EAGLE RANCH ROAD, N.W.

CHANGE ORDER NO. 7

SHEETS 1,4,5,6,7,8,9,10,11

The above-mentioned sheets are temporary additions to the final plans for Eagle Ranch Road. They outline the paving plan for completing approximately one half of the road as directed by the owner. Upon completion of the entire road section, these sheets shall be replaced by the originals.

ENGINEER'S SEAL		DATE: MARCH, 1985	COMMUNITY SCIENCES CORPORATION	APPROVED FOR CONSTRUCTION ALC ha CITY ENGINEER 4-1-85 DATE
SCALE: N/A		DESIGNED: G.A.		
DRAWN: CS		JOB NO: 73-24-PRE		
PROJECT NO. 2440		SHEET 1 OF 16

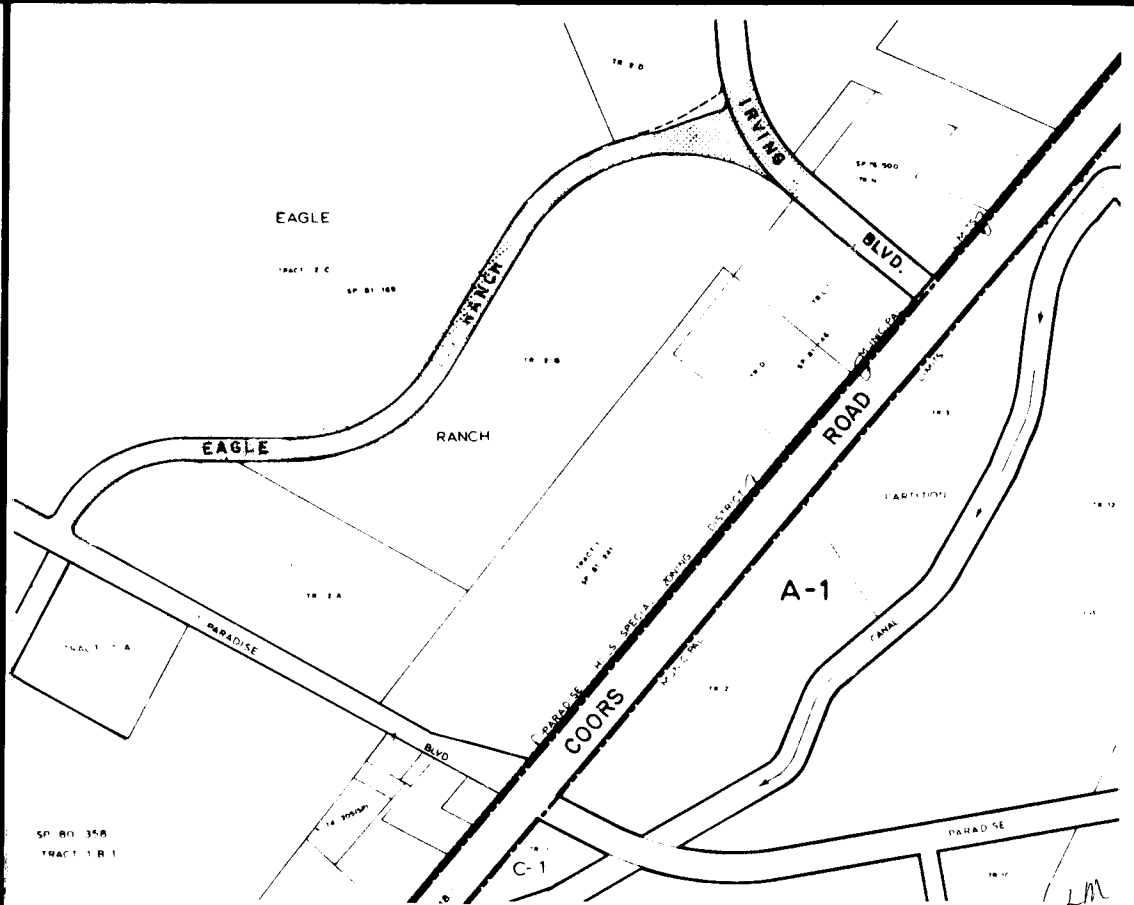
Note that no alterations were made to any permanent horizontal or vertical alignments. The only changes on these sheets involve temporary elimination of road section, curb and gutter and temporary construction of asphalt pavement and curb, which were drawn by Easterling & Associates, Inc., February, 1986.

DRAWING NO.	MAP NO.	SHEET	OF
2440	C-13	5	16

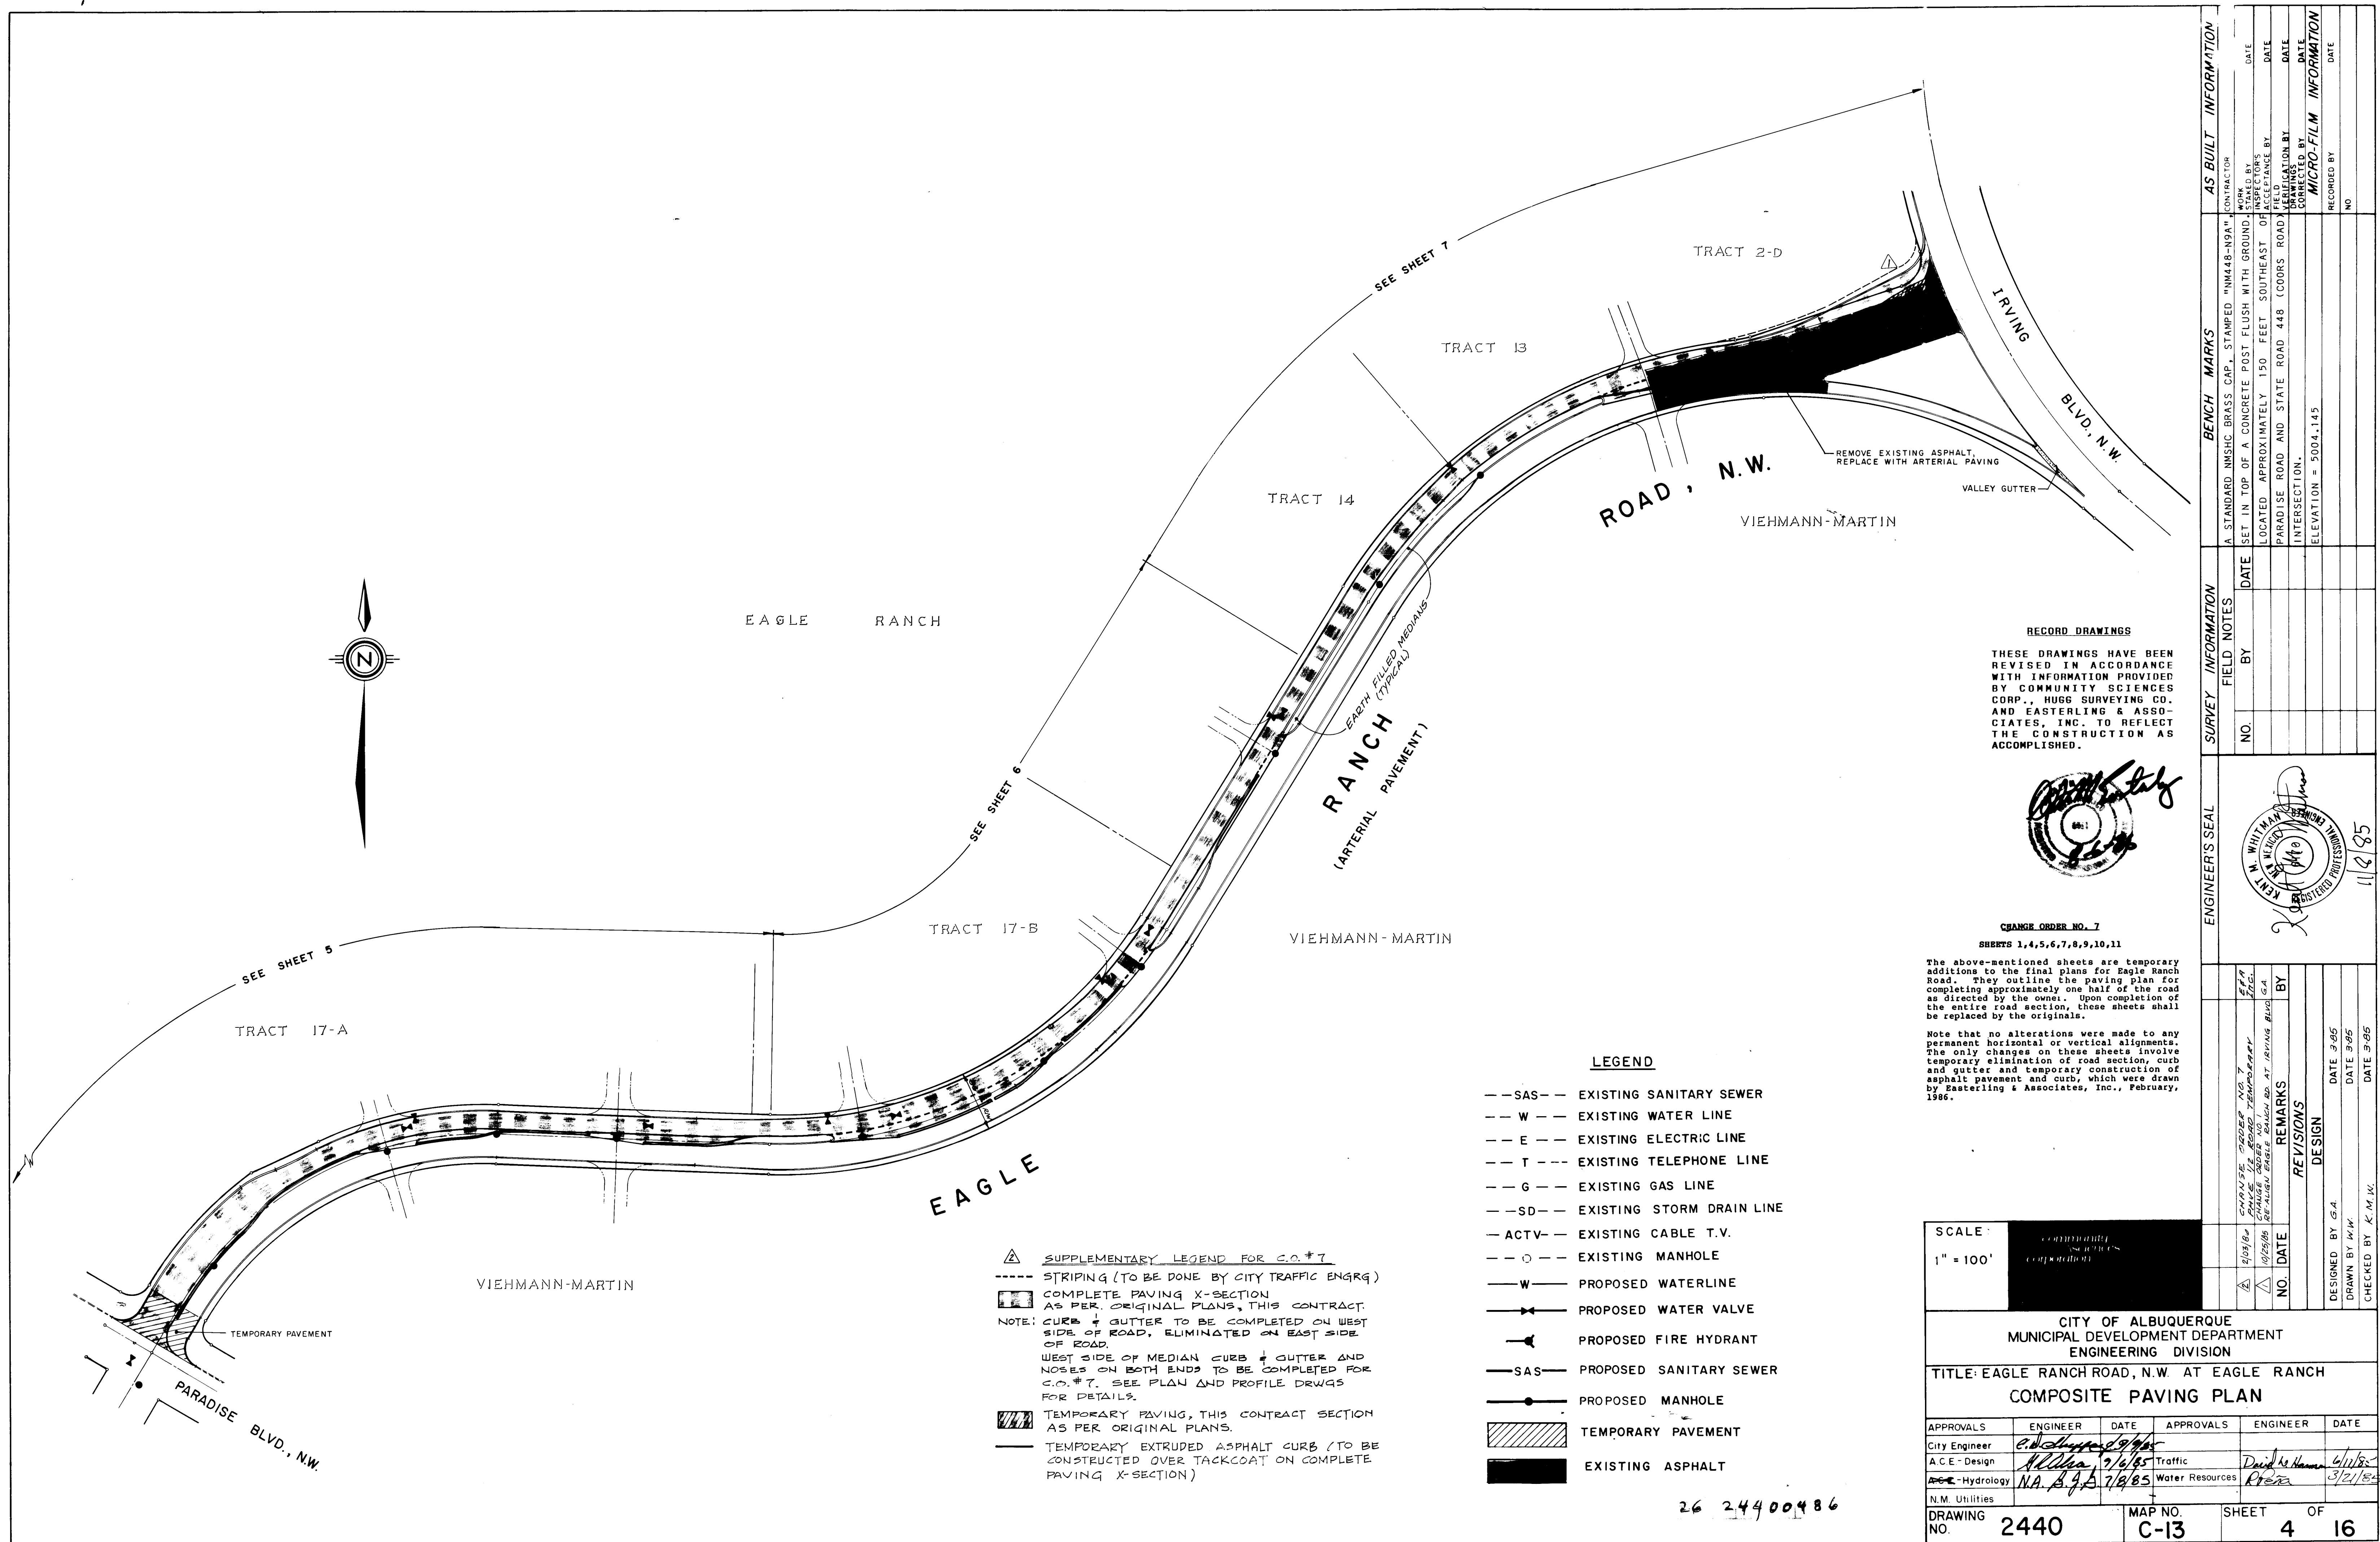
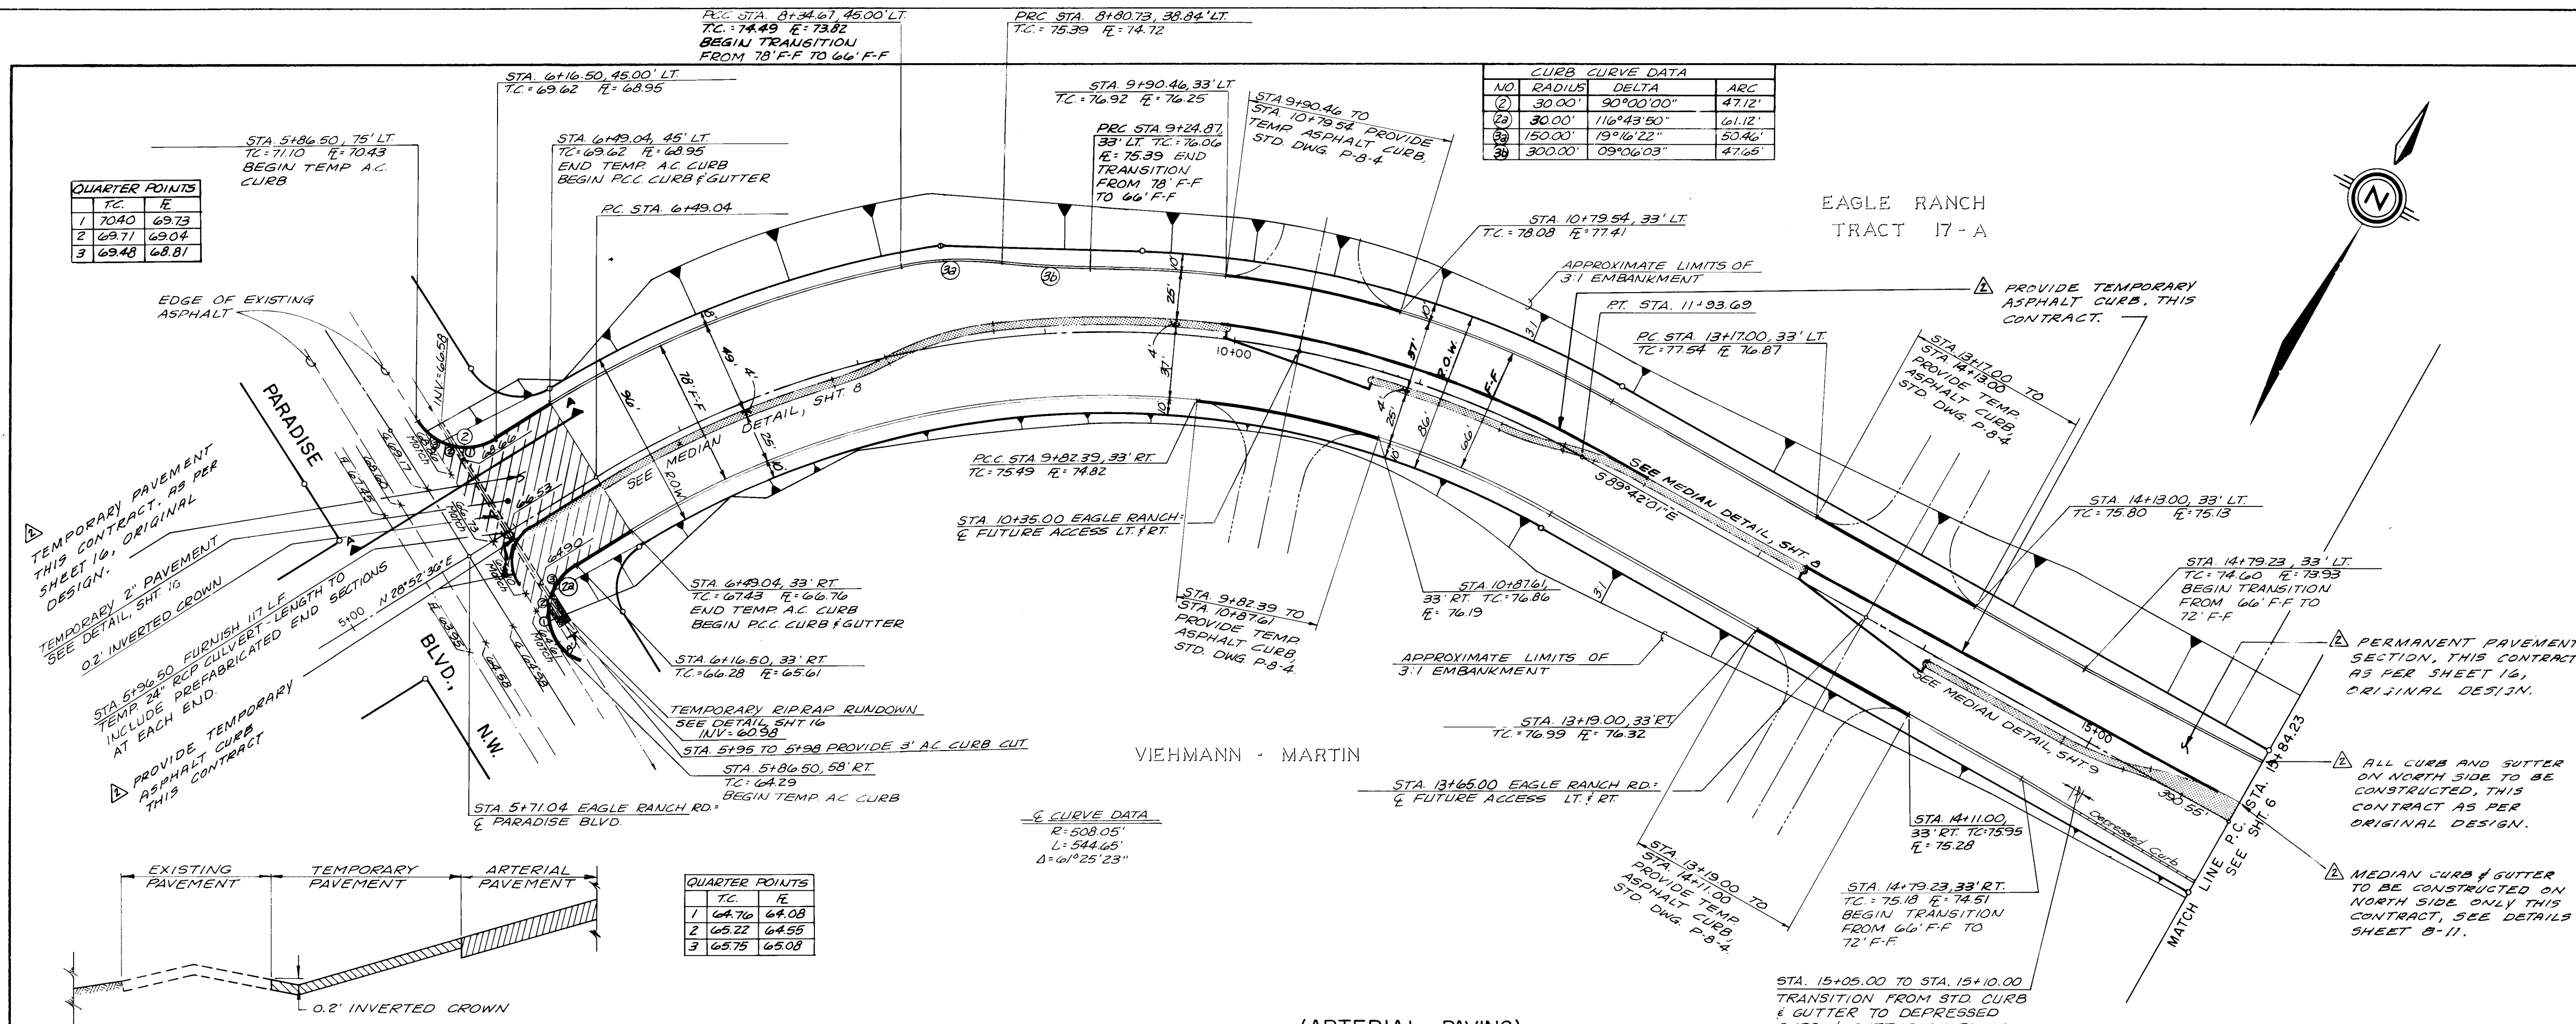
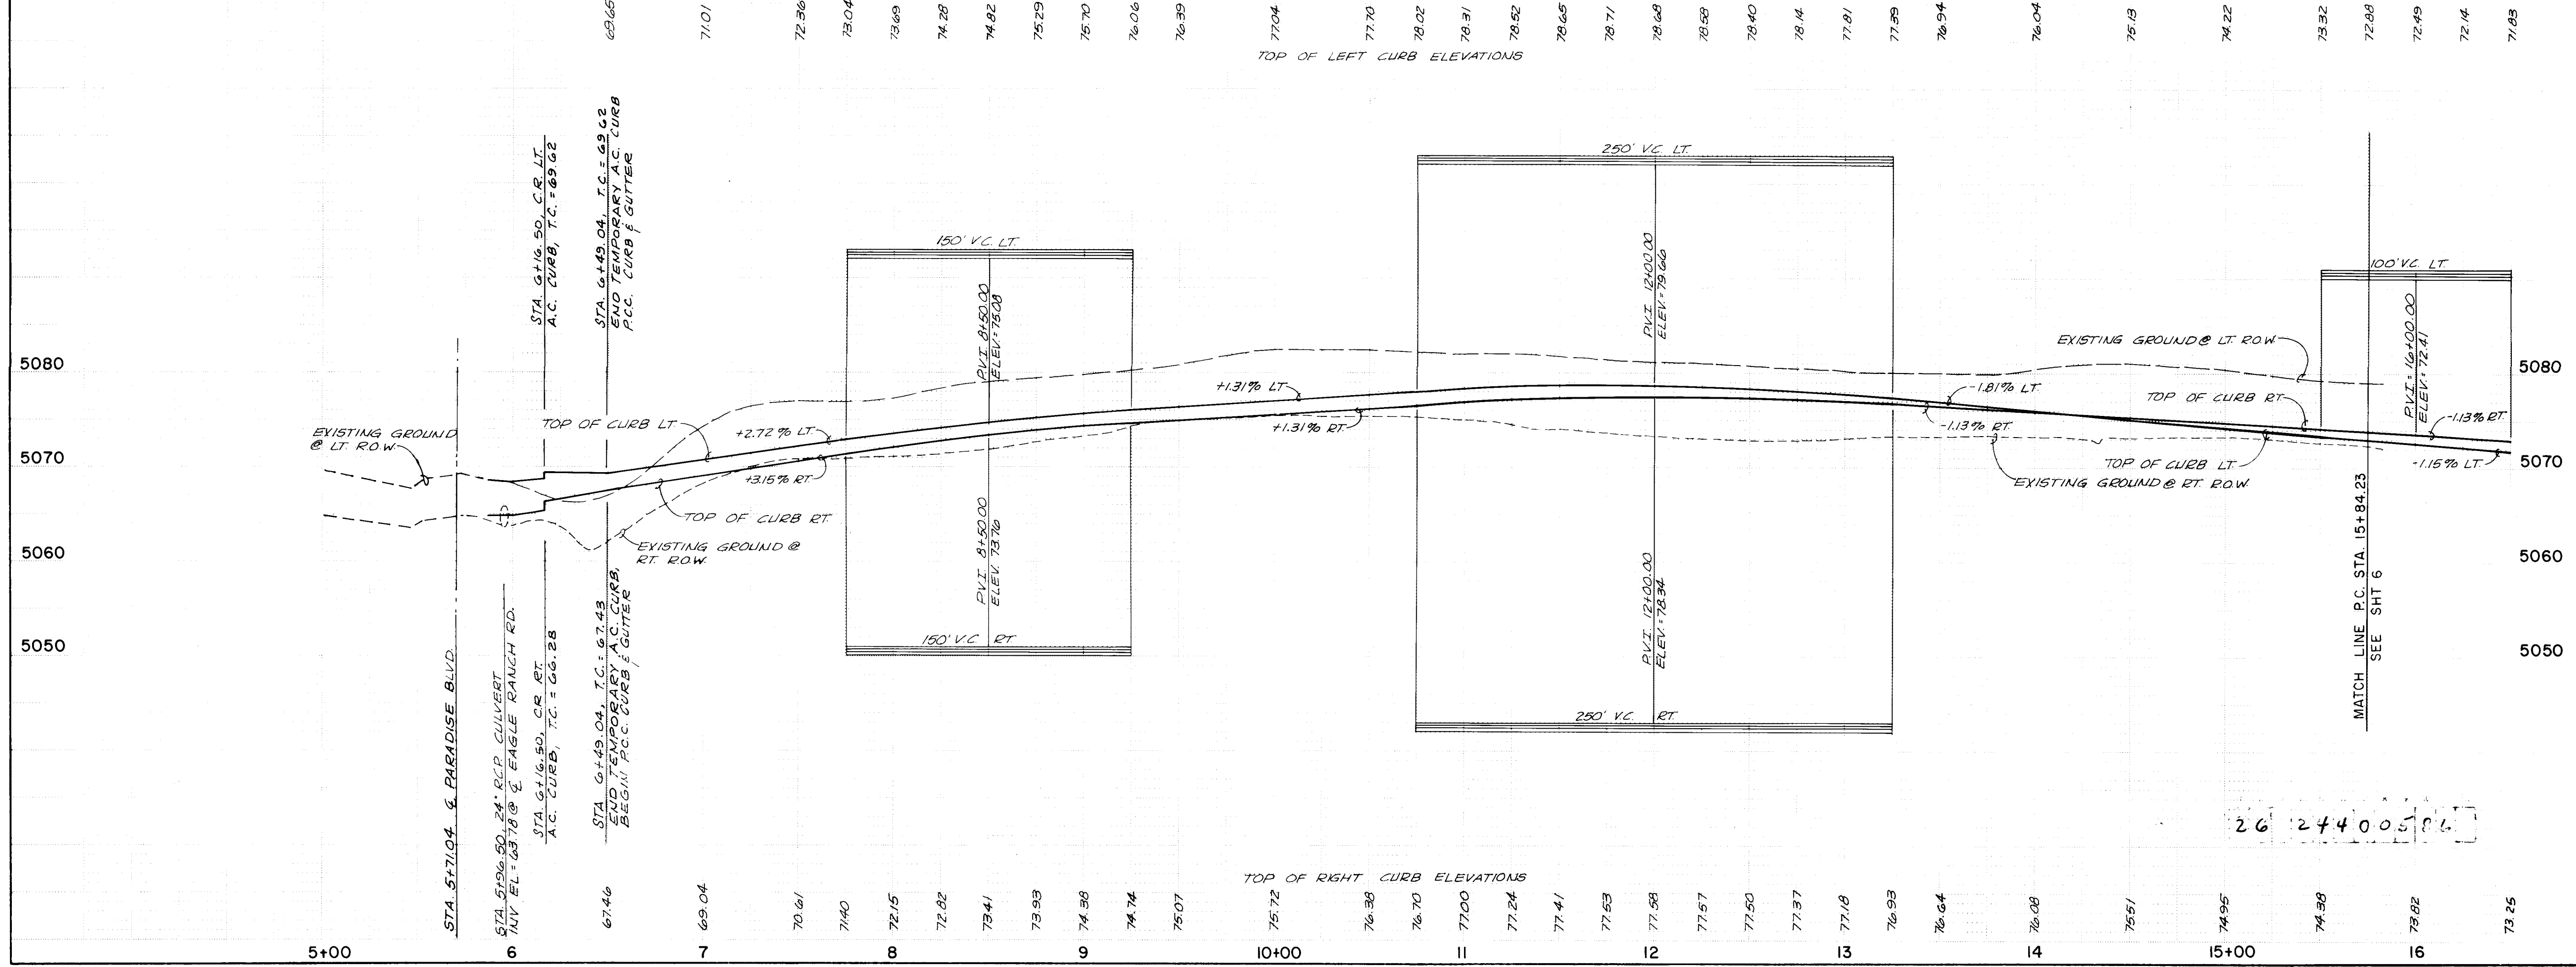
The above-mentioned sheets are temporary additions to the final plans for Eagle Ranch Road. They outline the paving plan for completing approximately one half of the road as directed by the owner. Upon completion of the entire road section, these sheets shall be replaced by the originals.

Note that no alterations were made to any permanent horizontal or vertical alignments. The only changes on these sheets involve temporary elimination of construction, curb and gutter and temporary construction of asphalt pavement and curb, which were drawn by Easterling & Associates, Inc., February, 1986.
